# Ground Floor Plan

S4.55 COMPARISON

# Ground Floor Plan

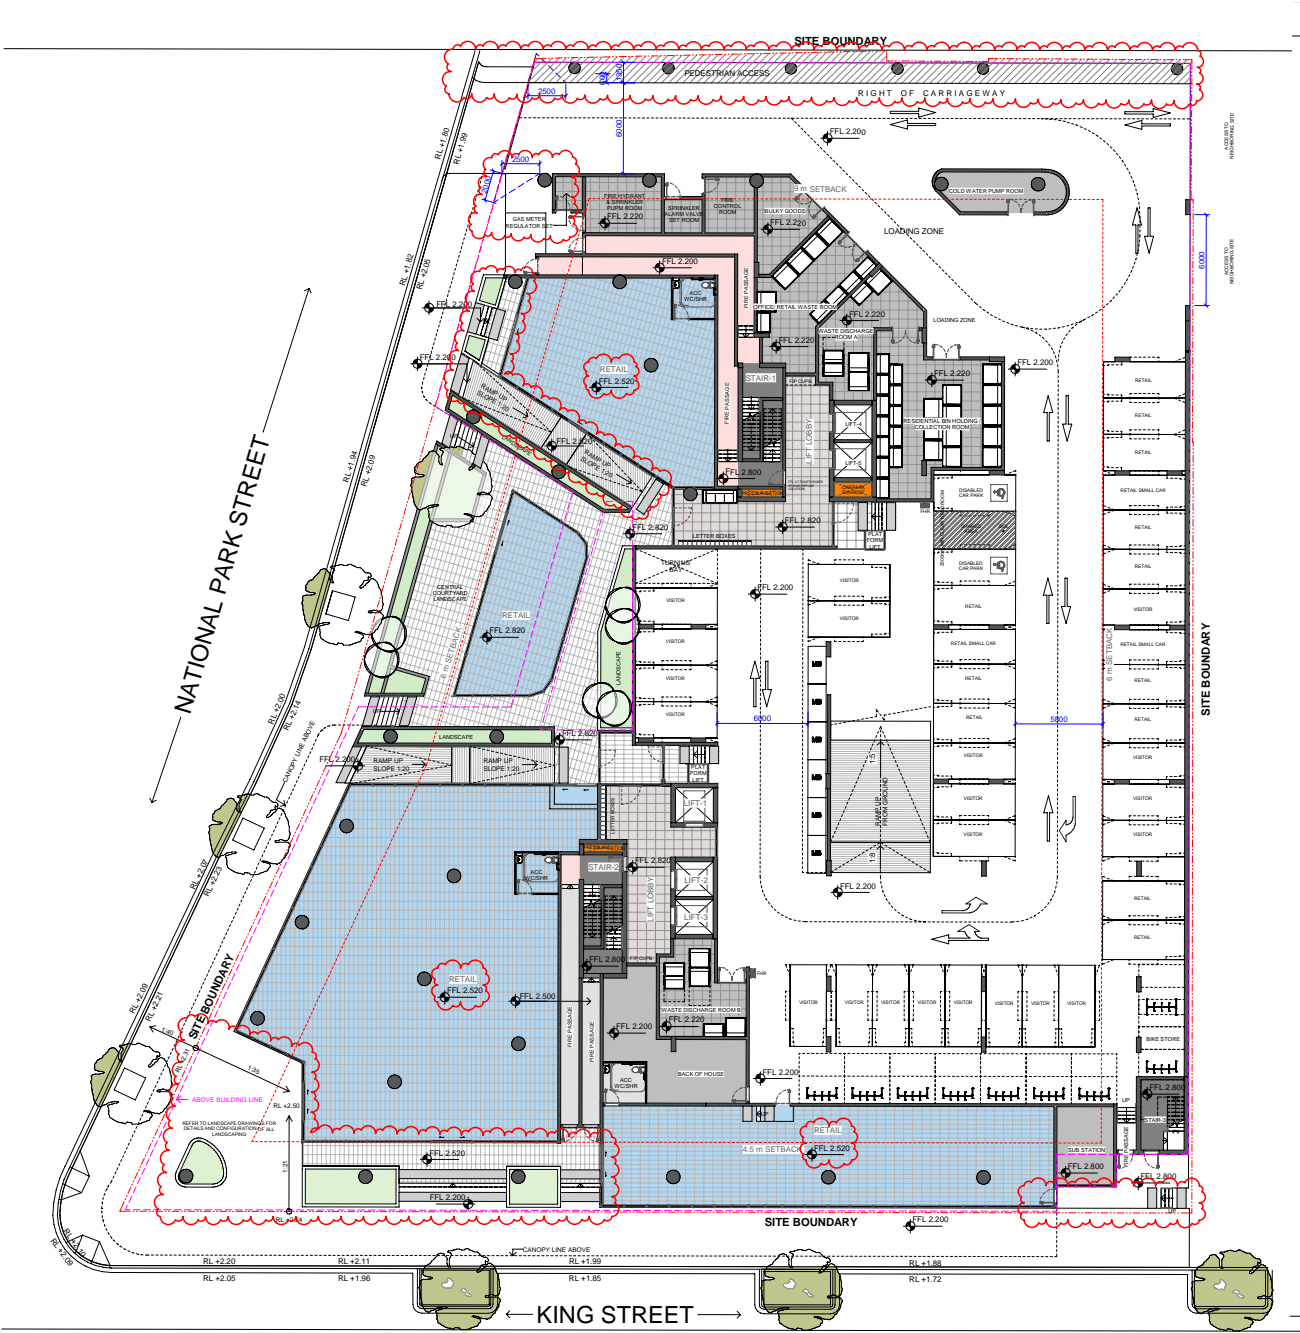
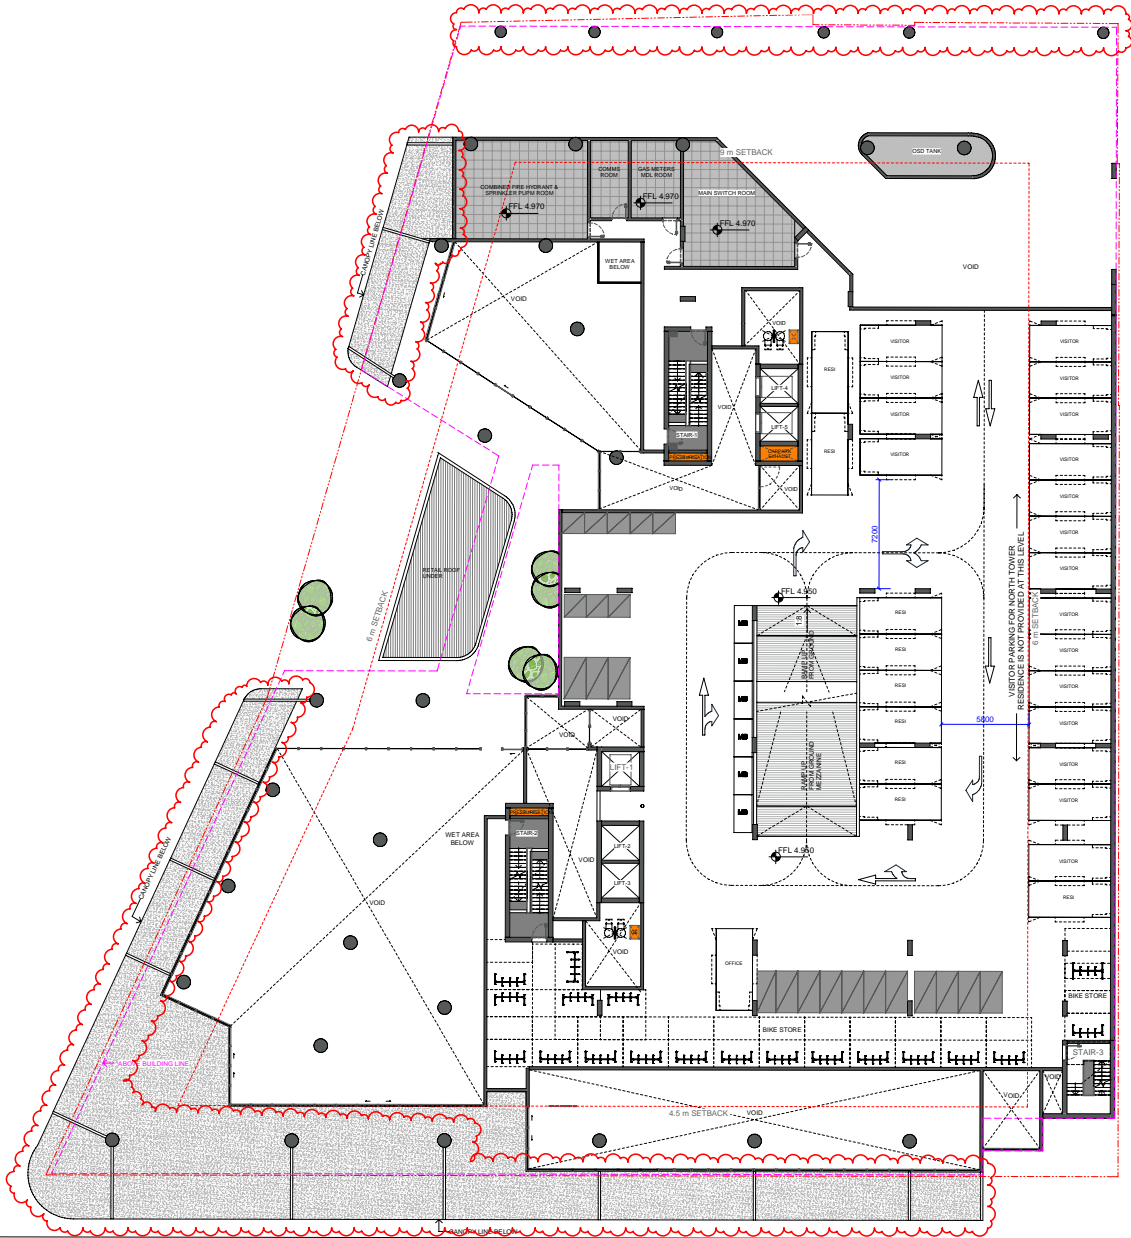
- 1. Lobbies changed:
  - a) Lift locations consolidated with stair following structural input.
  - b) South Tower only, ground to level 04 - 3 lifts changed to 2

- 2. Carpark rationalised to increase efficiencies:
  - a) Vehicle ramp moved to the West
  - b) Double stack carpark added
  - c) Notes added to confirm carpark clearances

- d) Secure roller gate & pedestrian access added to carpark entry
  - e) MRV turning circles added
  - f) Traffic Mirror & card reader
  - g) End of Trip Facility added

- h) Bike storage reconfigured to include secure storage
  - i) 12 EV charging points added to visitor car space
- 3. Detention tank added
- 4. Commercial changes

- a) Minor adjustments to floor plan geometry
  - b) G.02 integrated into podium to increase forecourt
  - c) Accessible bathroom added to G.02
  - d) G.02 shopfront extended to the West

- e) G.03 shopfront extended to the West
  - f) Columns adjusted following structural feedback
- 6. Increase depth of forecourt
  - a) Improved design and access - north ramp deleted

- b) Public art location
  - c) Additional external cafe seating
  - d) Address, feature and public interface of the development
- 6. Increase to substation size & main switch room added

- 7. Entry steps and ramp adjusted between commercial tenancies 3 & 4. Landscape planter bed adjusted to integrate with ramp design. Entry to tenancy 3 changed

- 8. King Street, street trees adjusted following Council's advice
- 9. Bus zone indicated at King Street front.
- 10. Clarifications to the Waste Store added.

- Area for 'Bulky Waste Goods' identified.
  - Area for each waste store added.
- 11. Entry to south tower lobby.
  - a) Glazing width increased
  - b) ramp and planter adjusted to open the space up in front of the entry

# Ground Floor Plan - Mezzanine

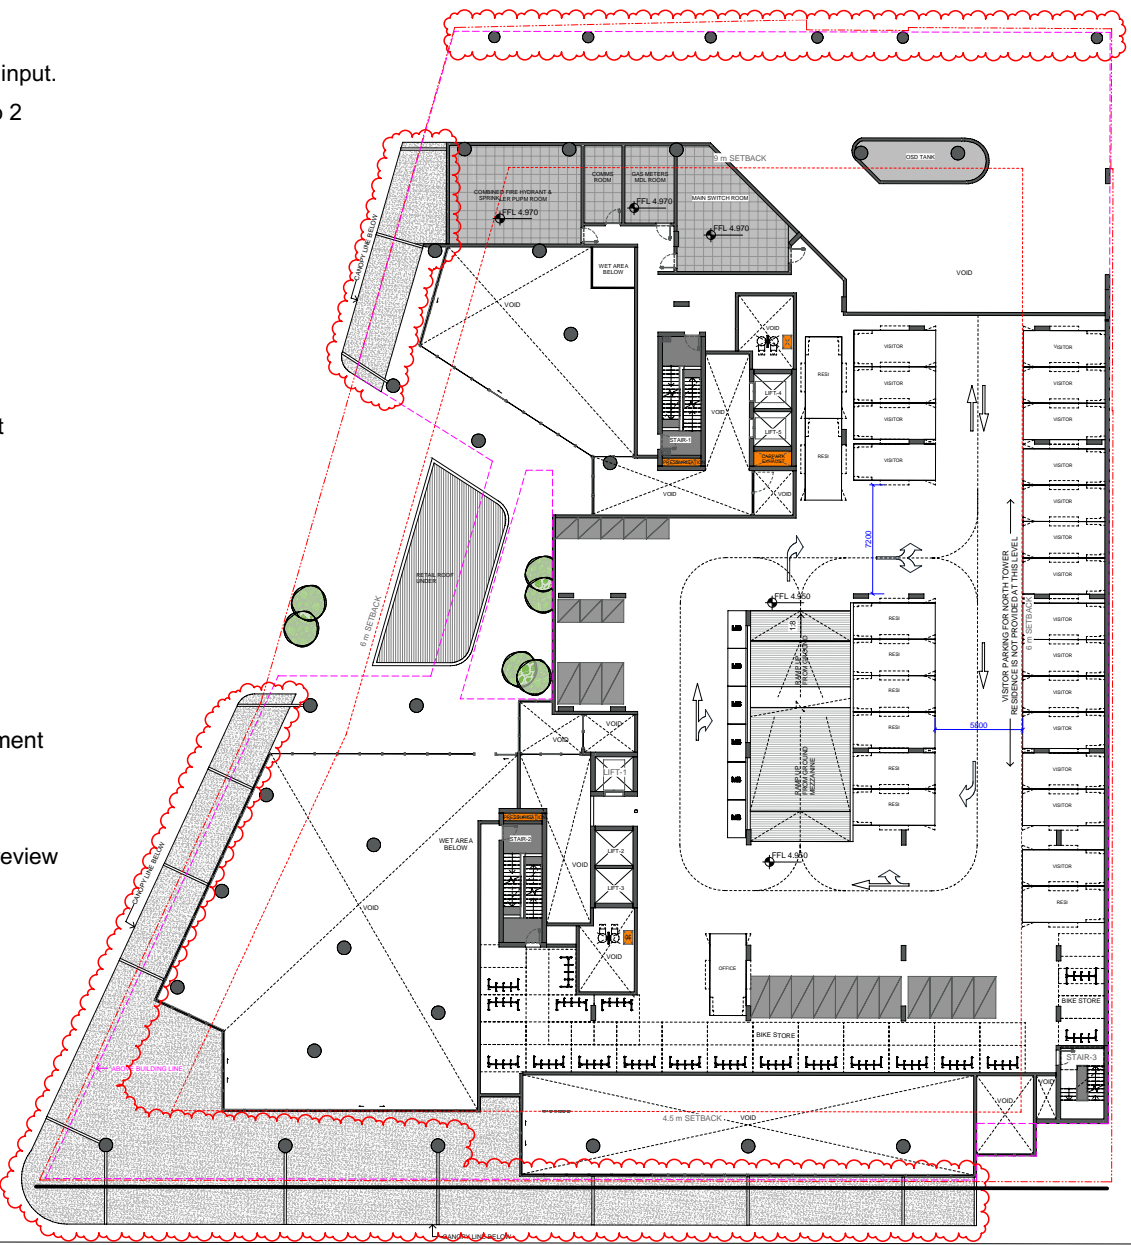
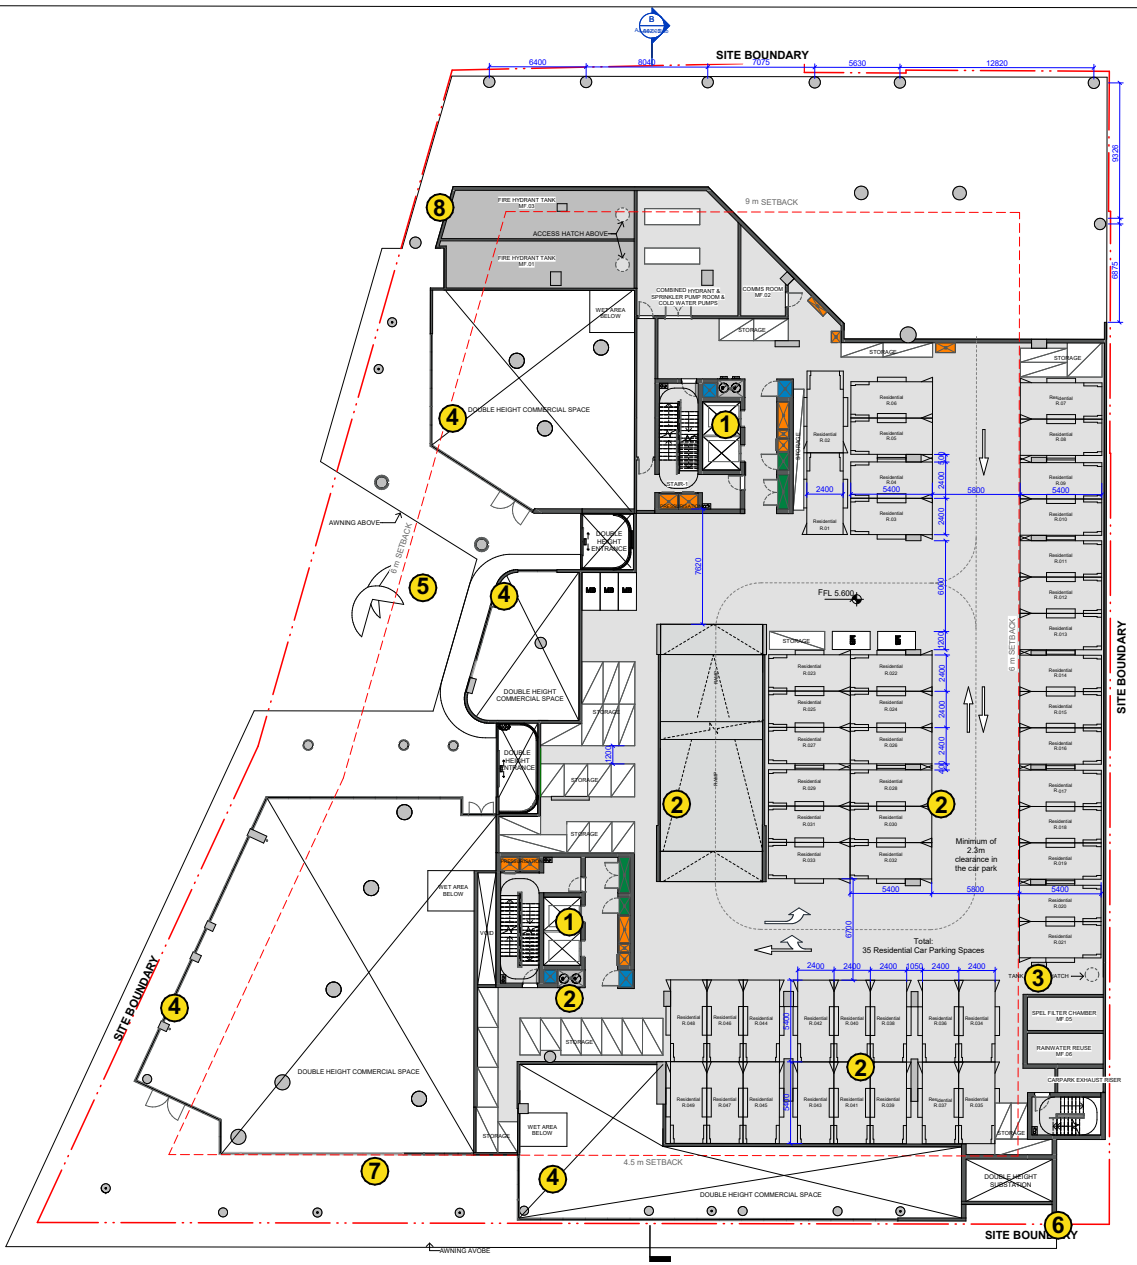
- 1. Lobbies changed:
  - a) Lift locations consolidated with stair following structural input.
  - b) South Tower only, ground to level 04 - 3 lifts changed to 2

- 2. Carpark rationalised to increase efficiencies:
  - a) Vehicle ramp moved to the West
  - b) Double stack carparks added
  - c) Bike storage replaced with storage allocated to units

- 3. rain water reuse & chamber added
- 4. Commercial changes
  - a) Minor adjustments to floor plan geometry
  - b) G.02 pushed back to provide more generous forecourt

- c) G.02 shopfront extended to the West
  - d) G.04 shopfront extended to the West
  - e) Columns adjusted following structural feedback
- 5. Increase depth of forecourt

- a) Improved design and access
  - b) Public art location
  - c) Additional external cafe seating
  - d) Address, feature and public interface of the development

- 6. Increase to substation size
- 7. Entry to commercial adjusted
- 8. Minor back of house changes following detailed service review

# Level 01 - Office Space

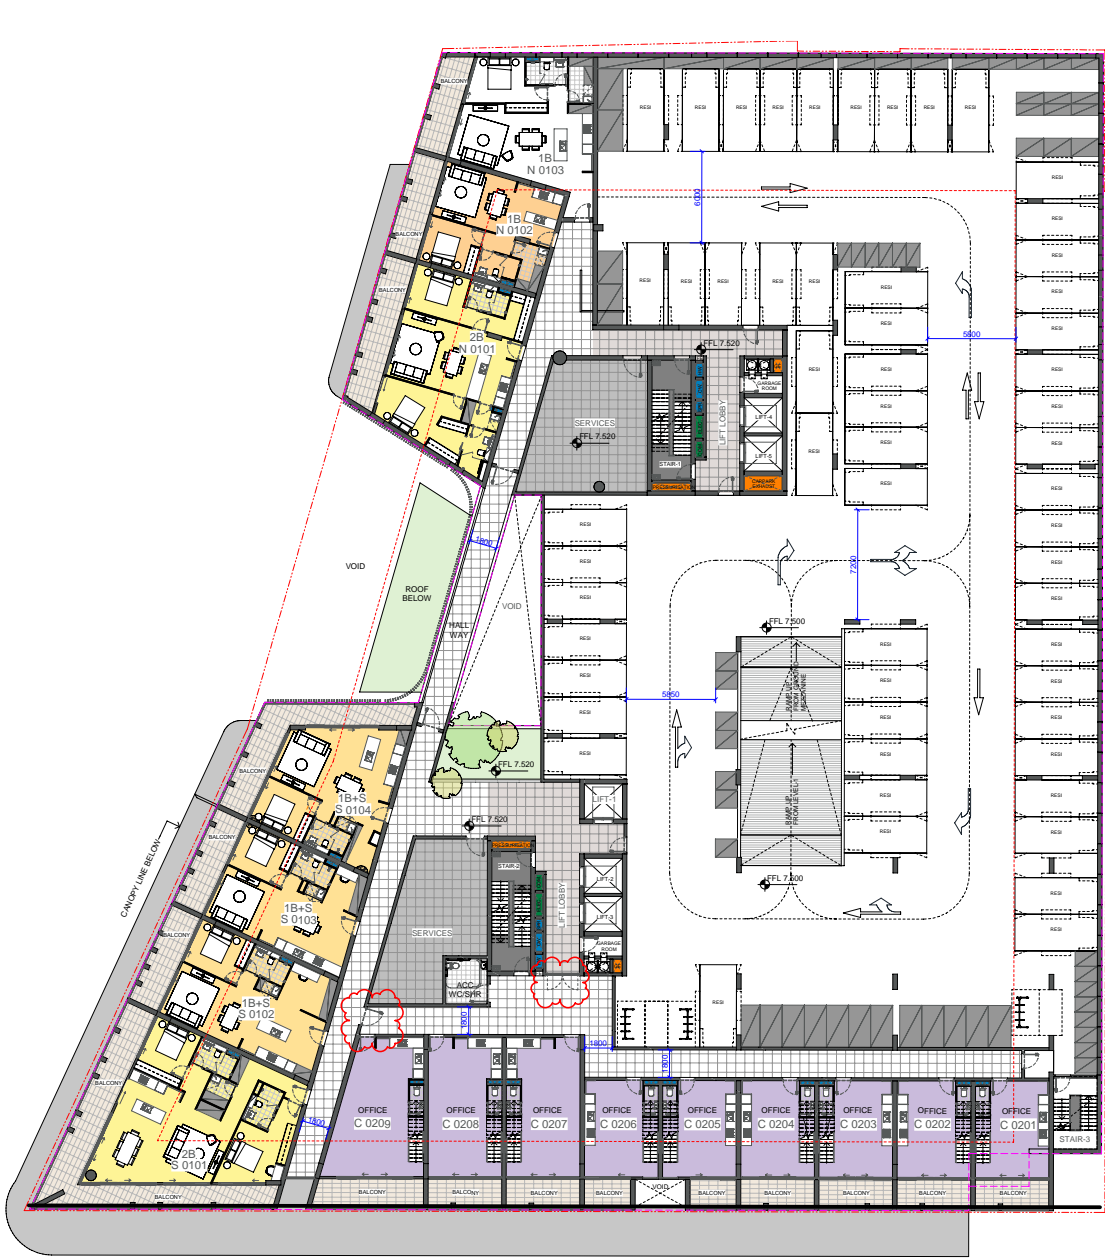
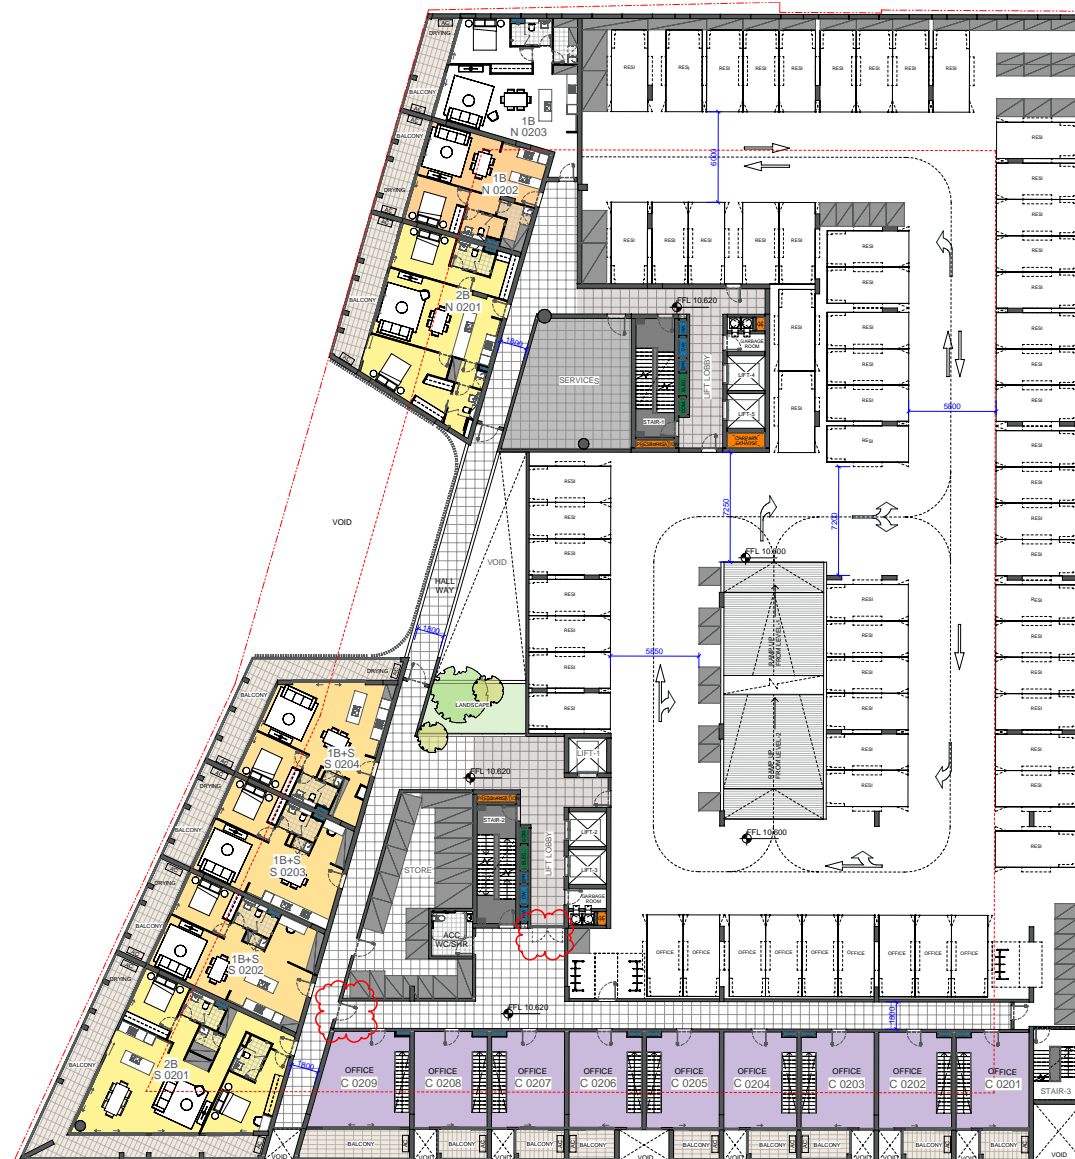
- 1. Lobbies changed:
  - a) Lift locations consolidated with stair following structural input.
  - b) South Tower only, ground to level 04 - 3 lifts changed to 2
  - c) Geometry of lobbies adjusted following detailed planning
- 2. Carpark rationalised to increase efficiencies:
  - a) Vehicle ramp moved to the West
  - b) Double stack carpark added
  - c) Bike storage replaced with storage allocated to units
  - d) Car spaces added to the South
- 3. Fire stair & carpark exhaust revised
- 4. Unit Planning changes
  - a) Minor adjustments to floor plan geometry
  - b) G.02 pushed back to provide more generous forecourt
  - c) G.02 shopfront extended to the West
  - d) G.04 shopfront extended to the West
  - e) Columns adjusted following structural feedback
- 5. Changes near forecourt
  - a) Increase depth of fourcourt
  - b) Commercial roof & void removed
